INSTRUMENT APPROACH CHART

RJDT / TSUSHIMA

RNP RWY14

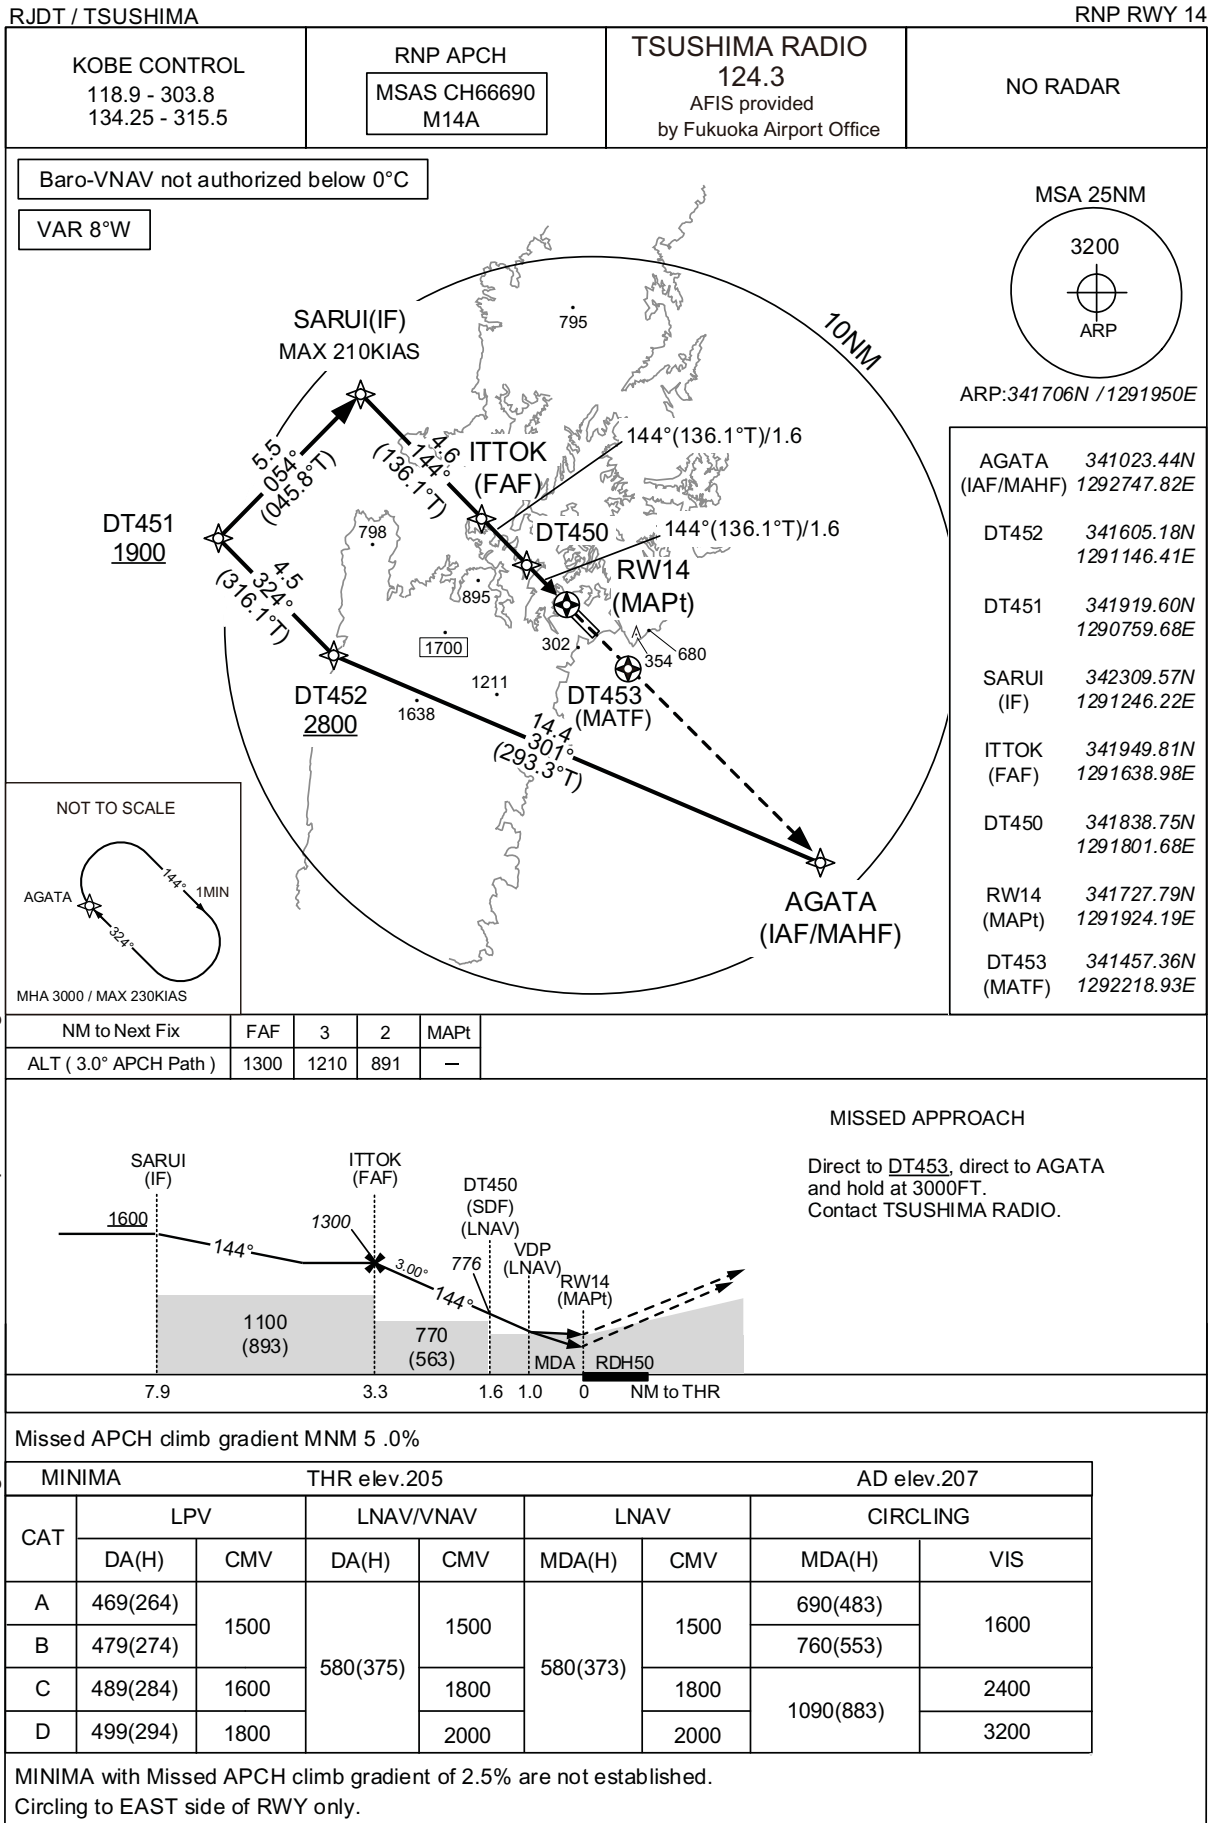
CHANGE : Missed APCH for using VOR/DME abolished. HLDG pattern for using NAVAID abolished.

CHANGE : Description of FAS DATA BLOCK ITEM(CRC remainder).
